TECHNICAL SERVICE BULLETIN (TSB) 20250321-02 Issued March 21, 2025

23-8-SS & 23-8-SC Locknut Replacement

UPDATE: Clarification on the 23-82-MO Wedge Lock Washer

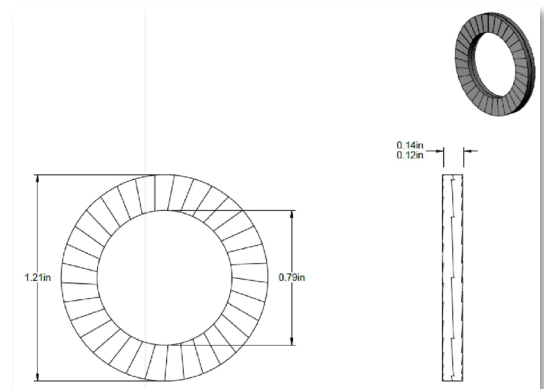
Summary: The 23-8-SS & 23-8-CS locknuts are being discontinued due to ongoing supply chain issues.

Beginning March 21, 2025, these locknuts are being transitioned to the following two items:

- 23-81-SS: THIN HEX NUT, 3/4-16, 18-8 STAINLESS STEEL
- 23-82-MO: WEDGE LOCK WASHER, 316 STAINLESS STEEL
 - This wedge lock washer consists of two pieces. See drawing below.
 - Placing an order for (1) 23-82-MO will include (2) pieces, or (1) set.
 - The Torque specification remains unchanged from the 23-8-SS & 23-8-CS specification.
